AXOD/AXODE (AX4S) UPDATE HANDBOOK

*Updated
October, 2002*

Since the introduction of the Ford AXOD transaxle in model year 1986, there have been many major engineering design changes that have affected many of the parts used in the AXOD transaxle. This version of the AXOD "Update Handbook" begins with the 1986 model year and will explain each change, the parts affected by the change, and any parts interchange problems created by the change. This booklet is an updated version of the original.

Figure 40

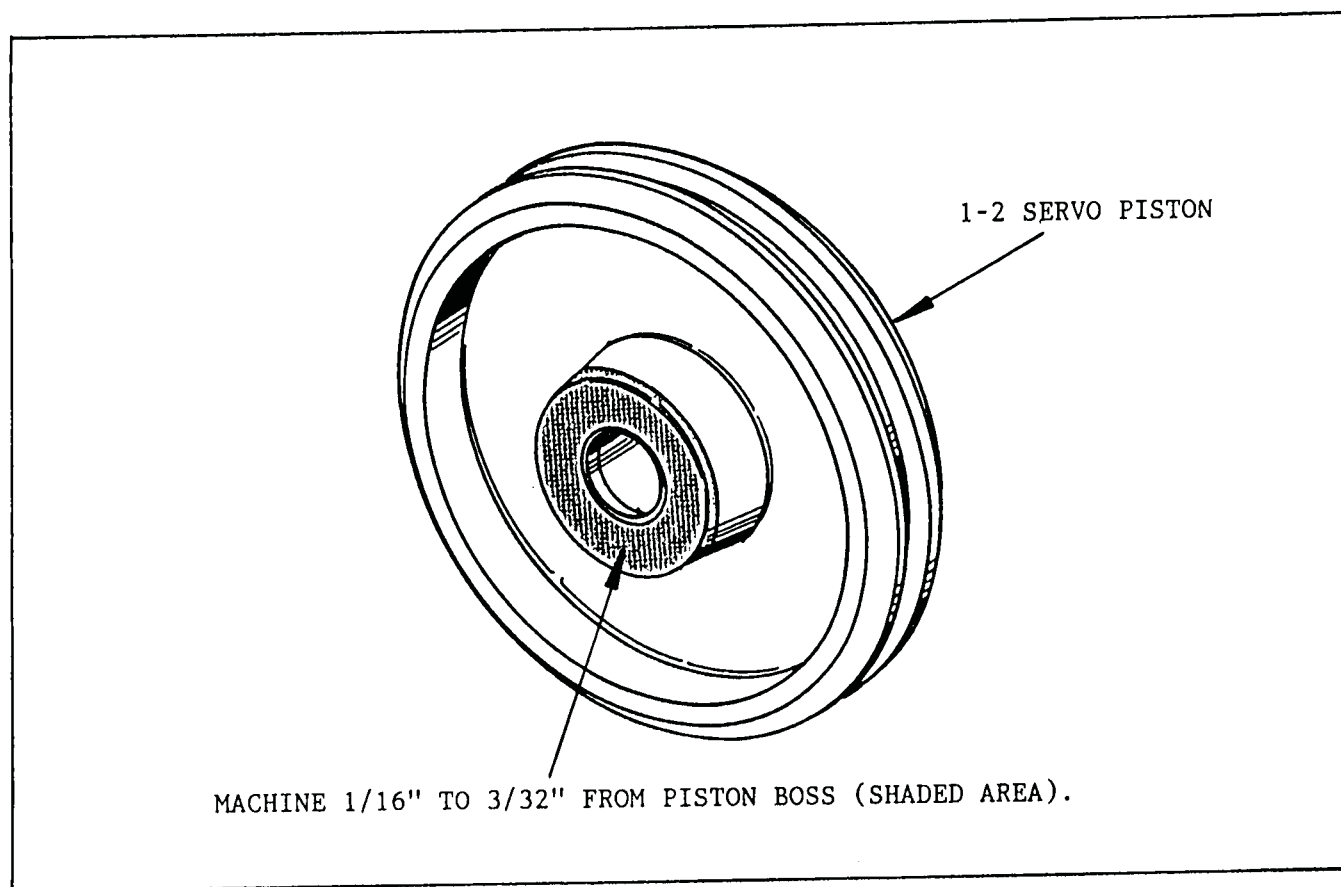
CAUSE: Insufficient travel of the 1-2 piston against the cushion spring.

CORRECTION: Remove 1/16" to 3/32" from the boss on the inside of the 1-2 servo piston as shown in Figure 40. We have shaded the area to be machined (See Figure 40).

Figure 41

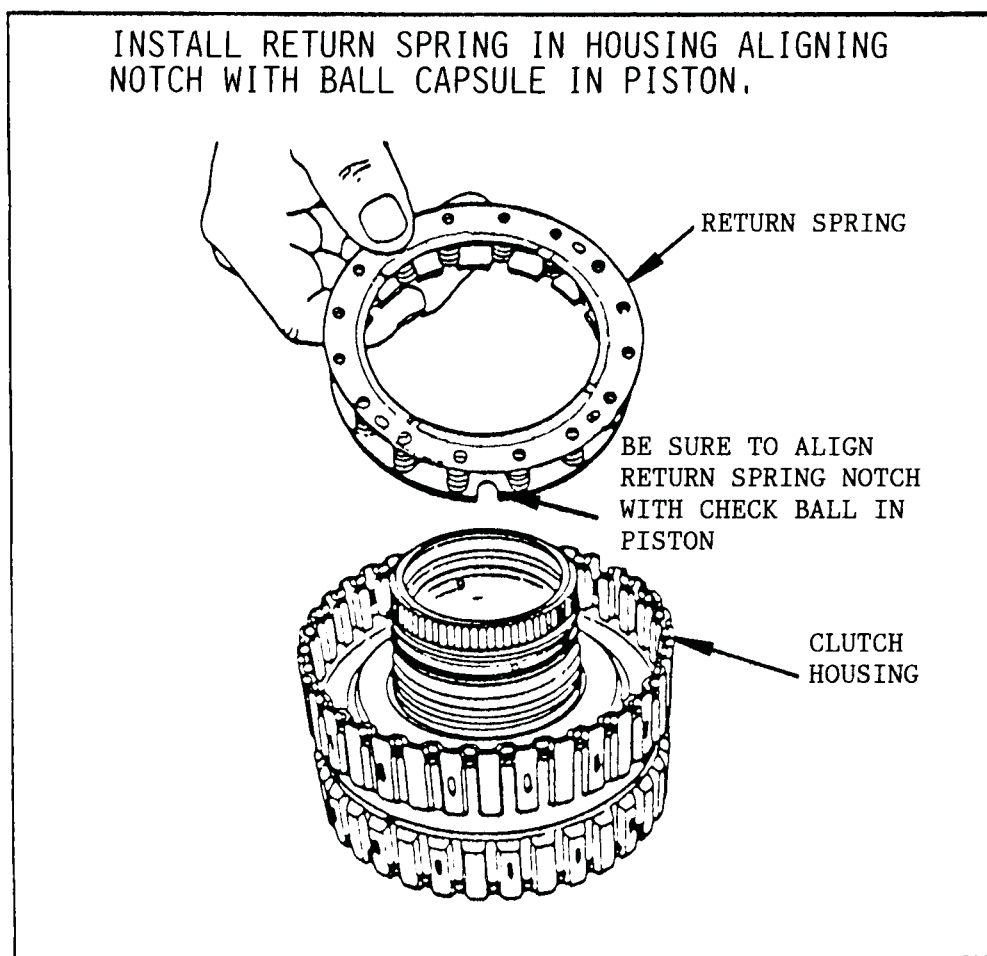
- COMPLAINT:** An extended 3-4 shift with possible direct clutch failure or a NO 3-4 shift condition.
- CAUSE:** This condition may be caused by a partially or fully blocked oil flow of the direct clutch piston check ball assembly.
- CORRECTION:** Special care must be taken during the overhaul operation when re-assembling the direct clutch return spring over the direct clutch piston. Make sure that the notch in the spring bottom retainer (See Figure 41) is positioned properly over the check ball capsule so as not to block or restrict oil flow of the check ball assembly. Refer to Figure 41.

Figure 43

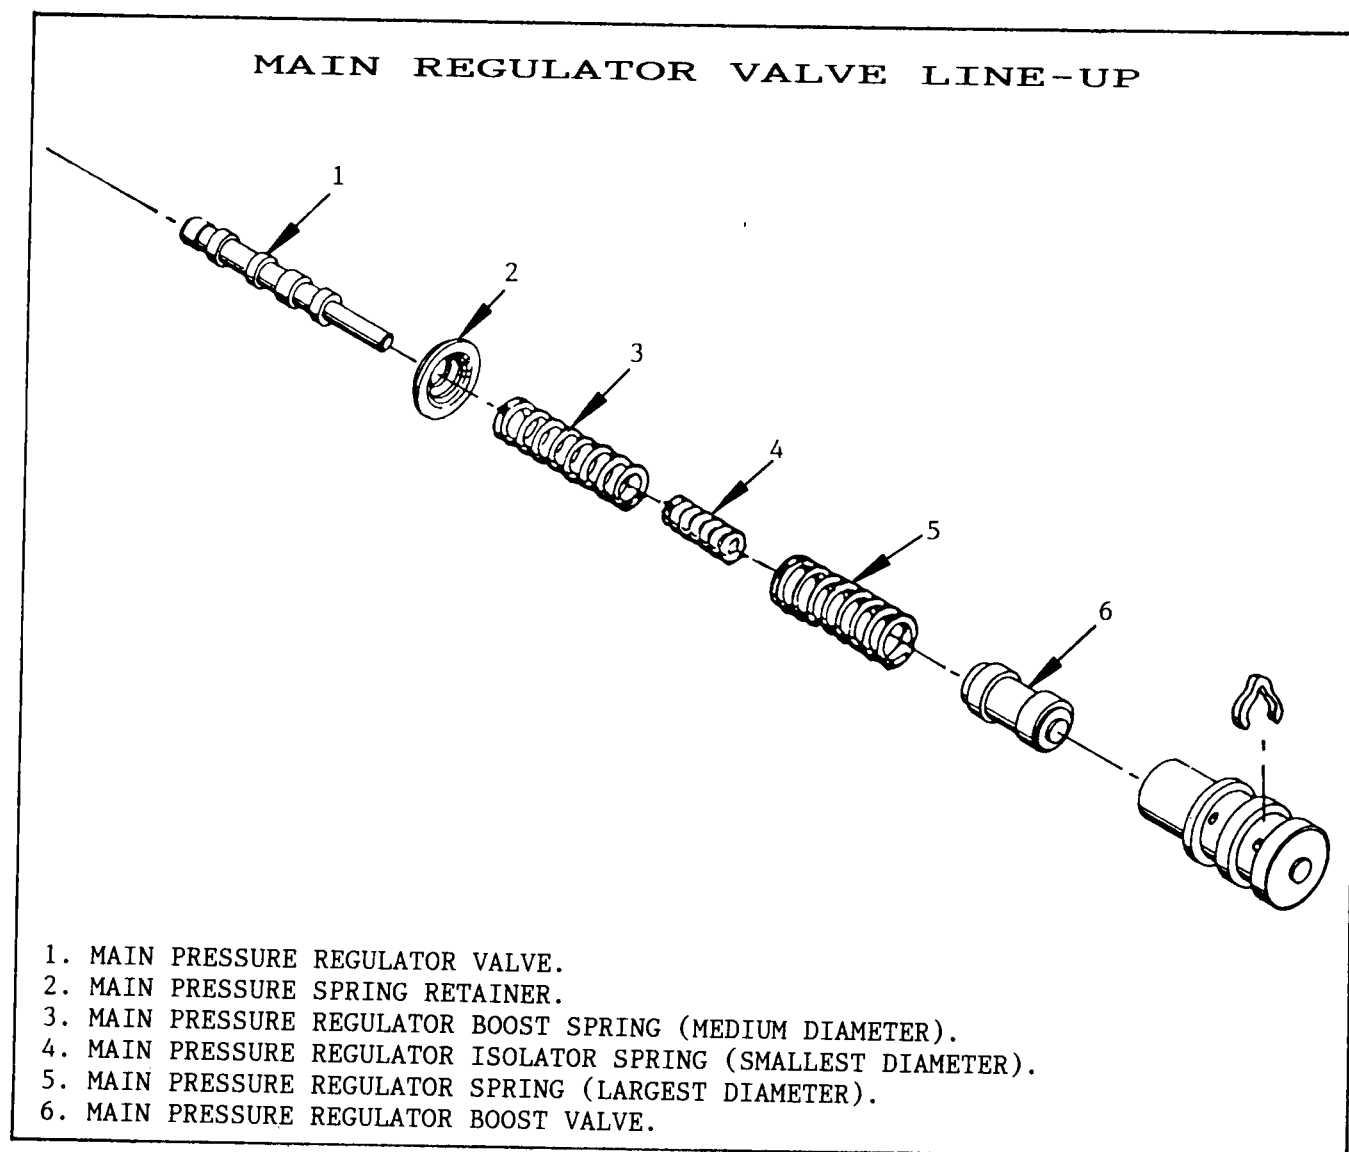
CAUSE: NO. 1. A "Shudder" during a 1-2 upshift will occur if the main pressure regulator "Isolator" spring is not installed after cleaning the valve body (See Figure 43). This is caused by fluctuations in main line pressure at the time of the 1-2 shift.

NO. 2. Delayed upshifts can be caused by the pressure regulator spring retainer being installed backwards (See Figure 43). This will create low main line pressure.

CORRECTION: NO. 1. Insure that all three (3) pressure regulator springs are re-installed in the valve body regulator bore (See Figure 43).

NO. 2. Insure that the main regulator spring retainer is installed in the proper direction (See Figure 43). The retainer is very similar to the one used in the AOD valve body, but is installed in the opposite direction of the AOD (See Figure 43).

Figure 47

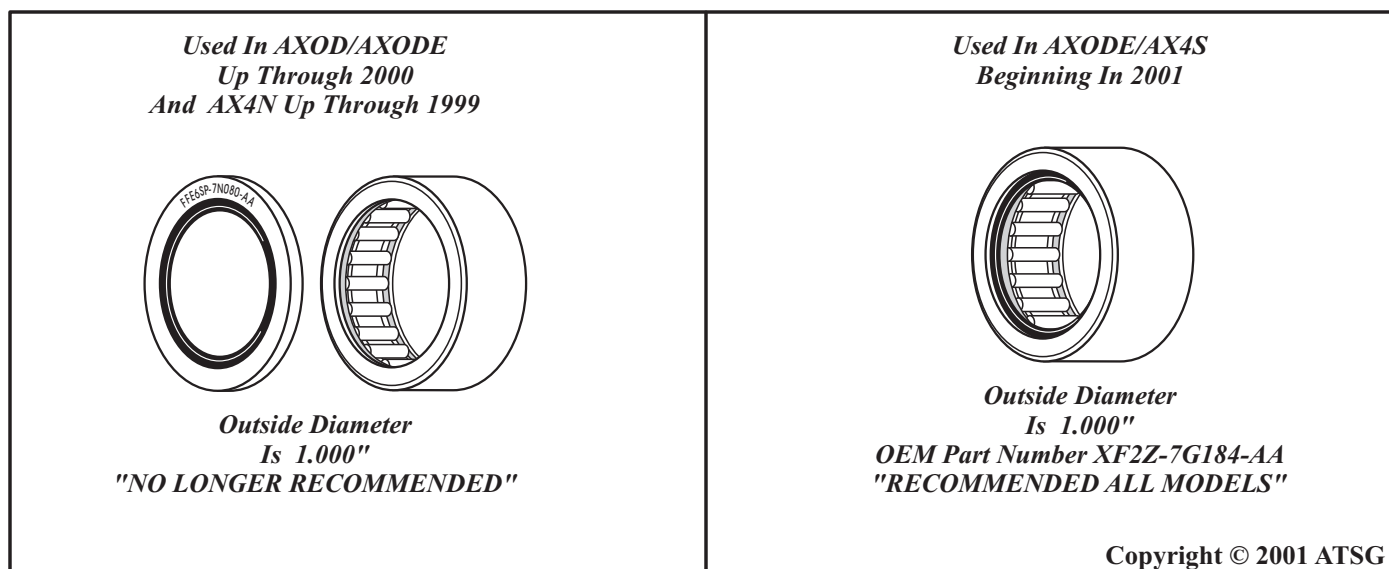
CHANGE: Beginning at the start of production for 2001 on all AX4S transaxles, Ford Motor Company introduced a new design pump bearing that includes an integrated seal, as shown in Figure 47. When this new design bearing and seal assembly went into production, it was installed with the ***seal on the valve body side of the pump instead of the rotor side.***

Figure 48

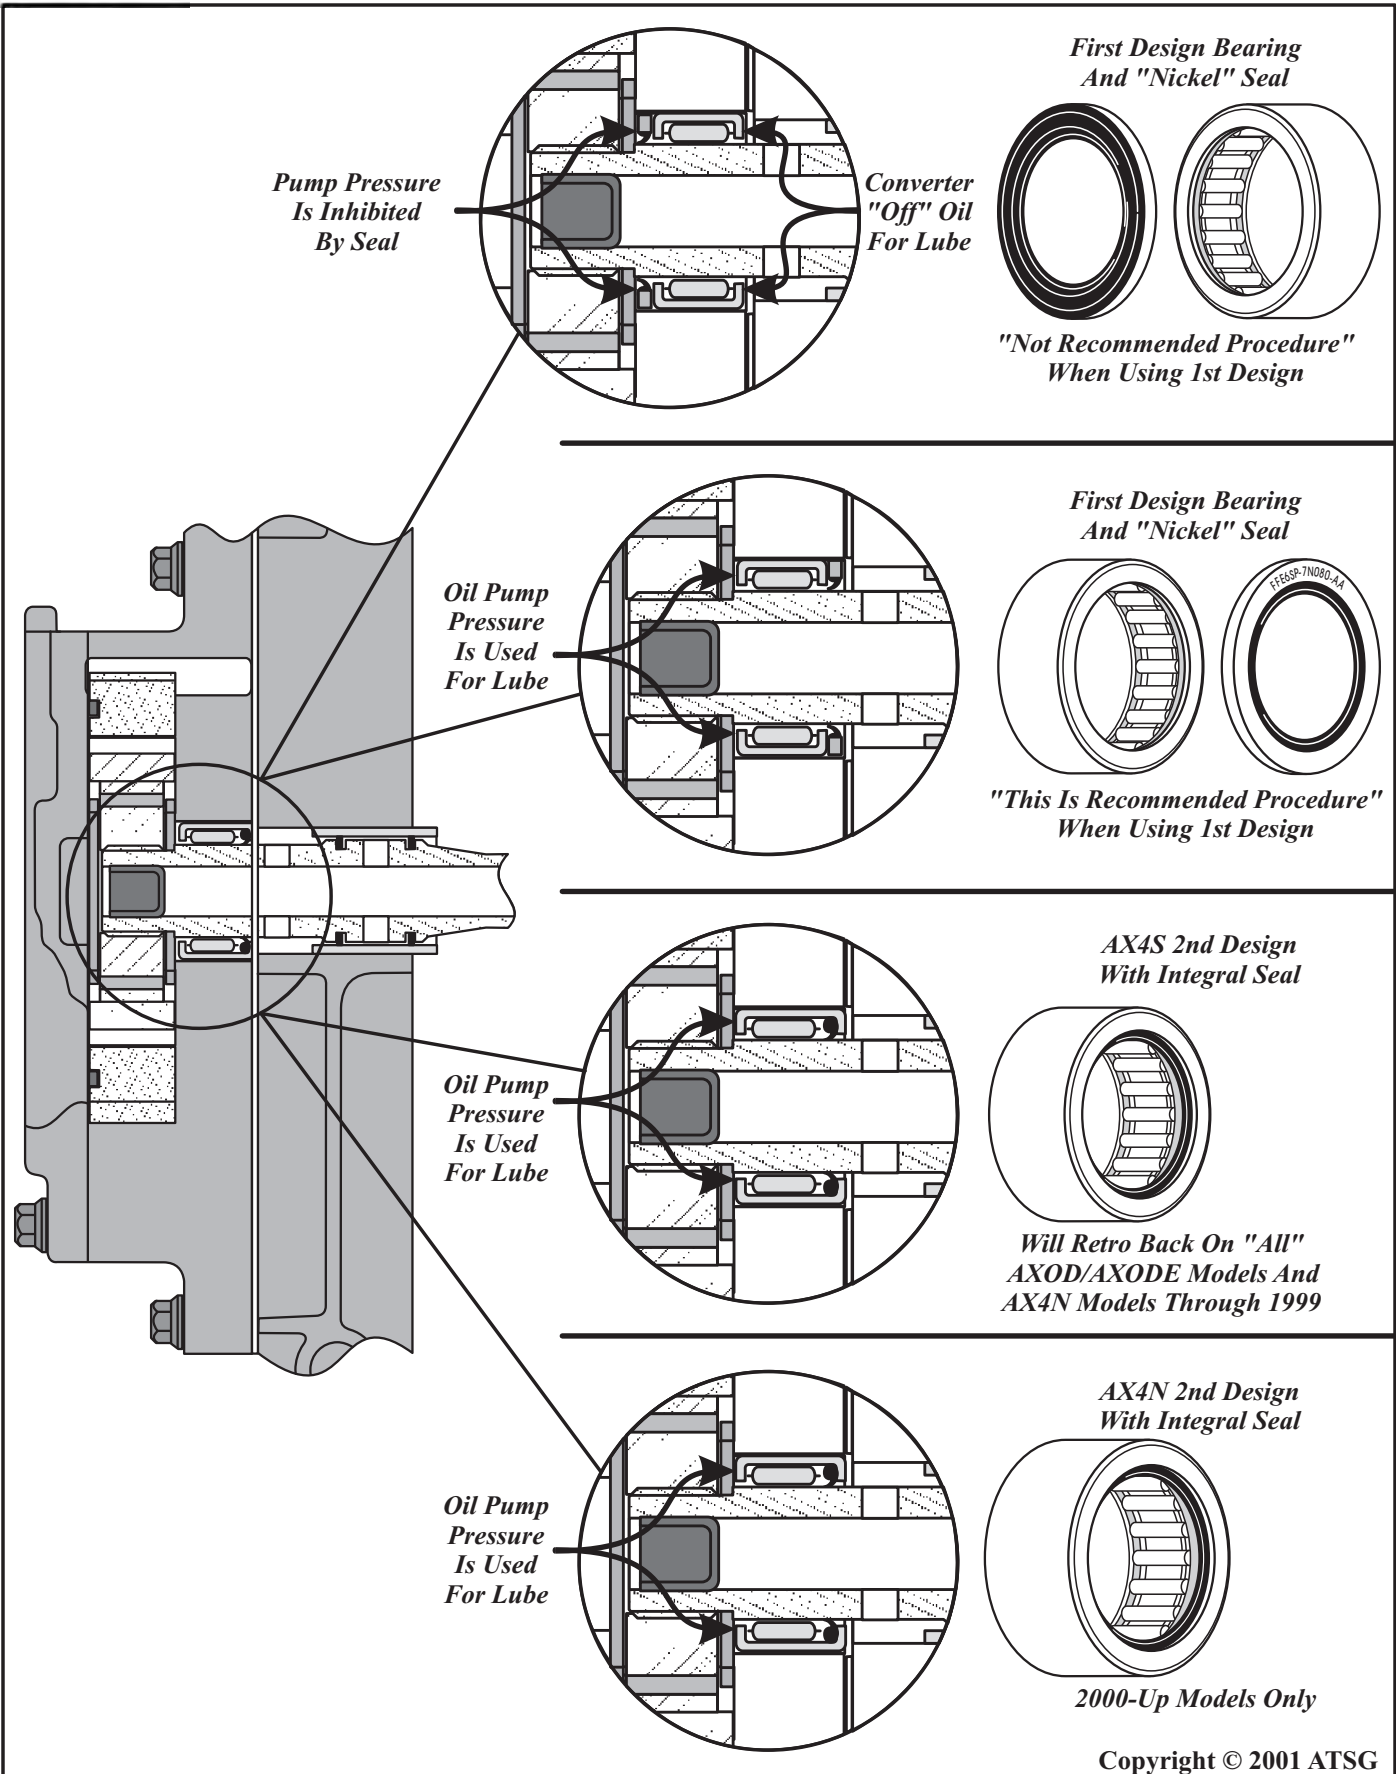
AXOD/AXODE (AX4S) - When using the 1st Design bearing with the "Nickel" Seal, install the seal on the valve body side, with the part number facing up, as shown in Figure 48.

Figure 54

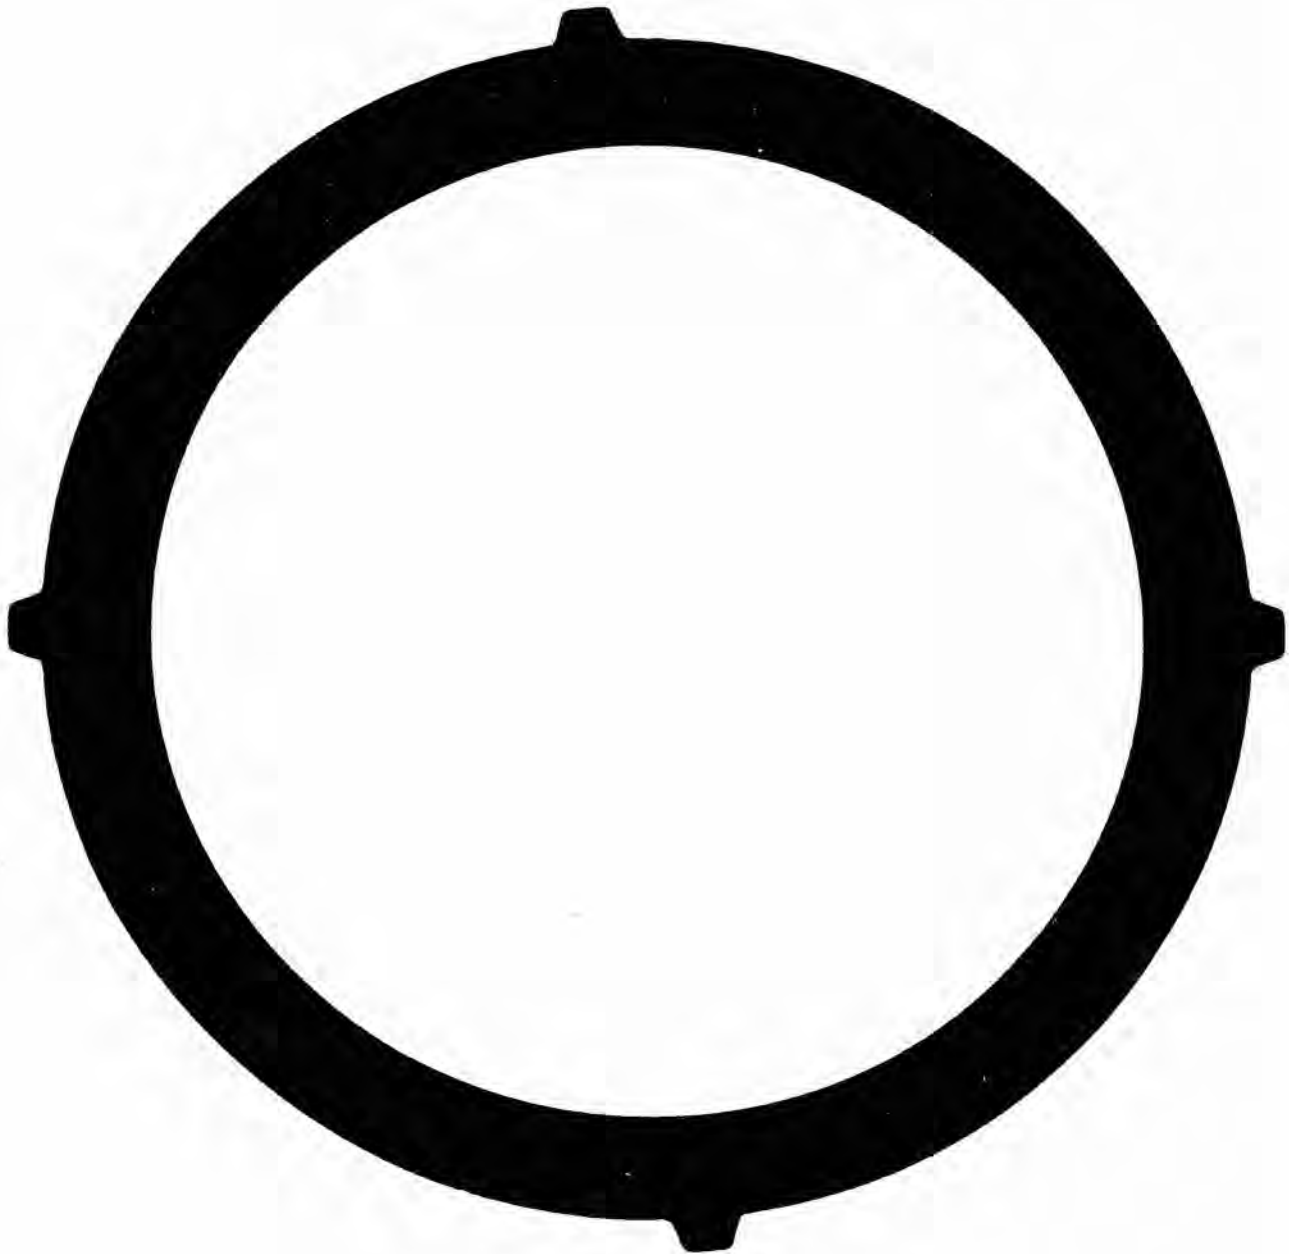
1ST DESIGN - Has 4 external teeth, an inside diameter of 4.715", material thickness of .062", and was used from 1986-1988. Refer to Figure 54.

Figure 55

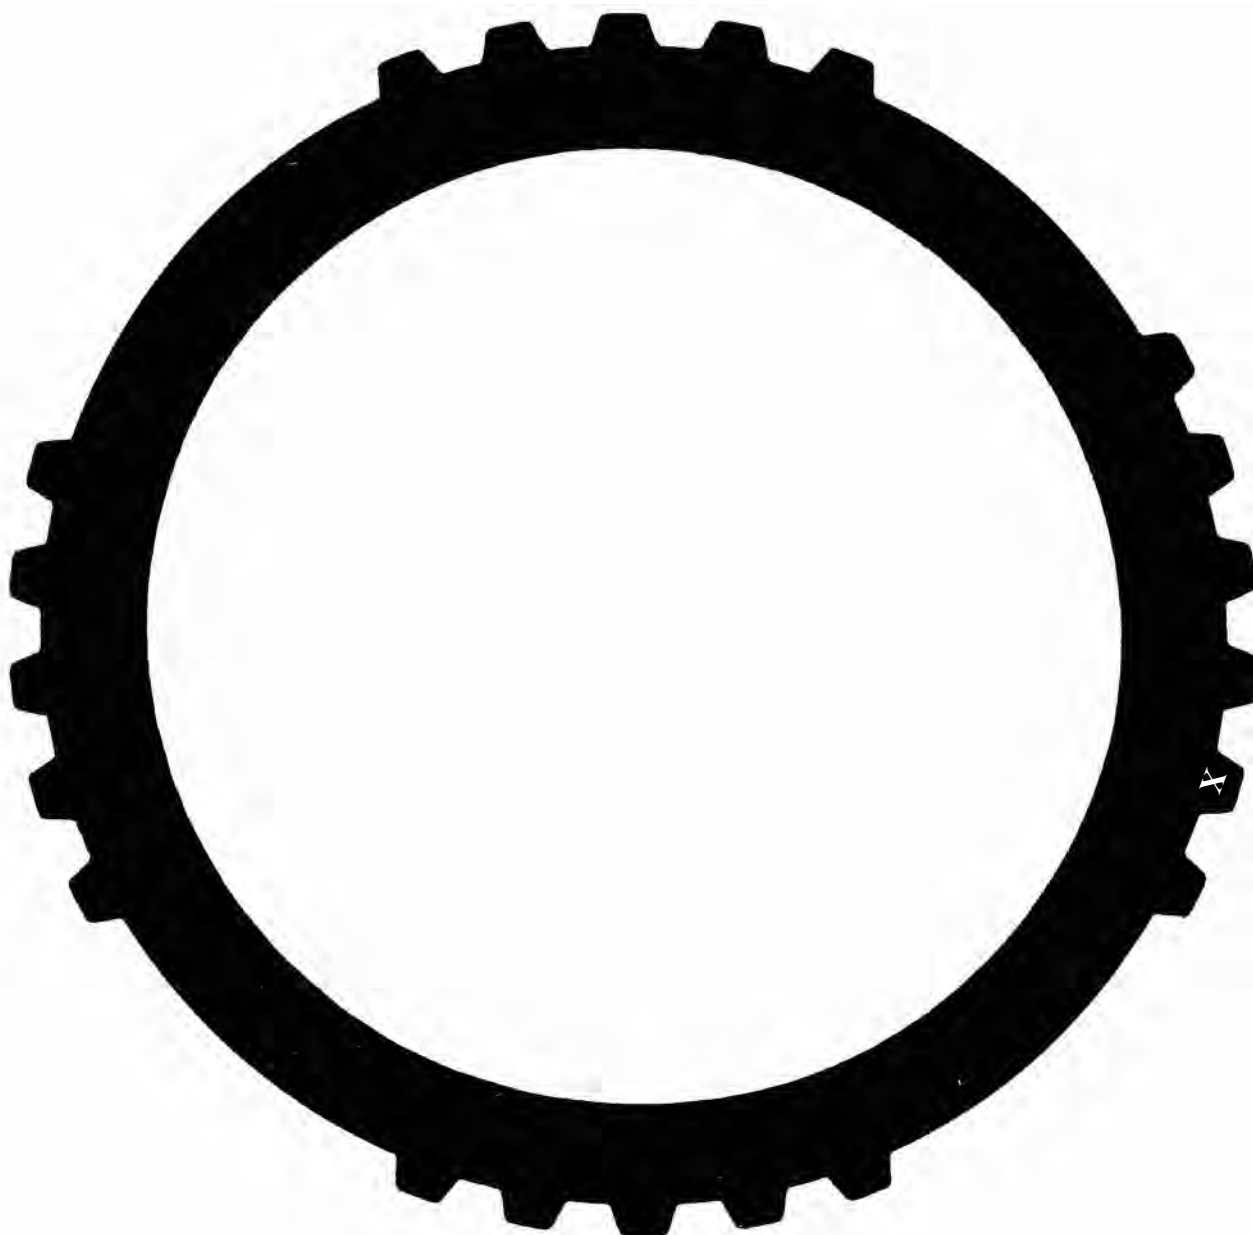
2ND DESIGN - Has 21 external teeth, inside diameter of 4.730", material thickness of .075", identified with letter "X" stamped on 1 tooth, and was used from 1989-1991. (See Figure 55).
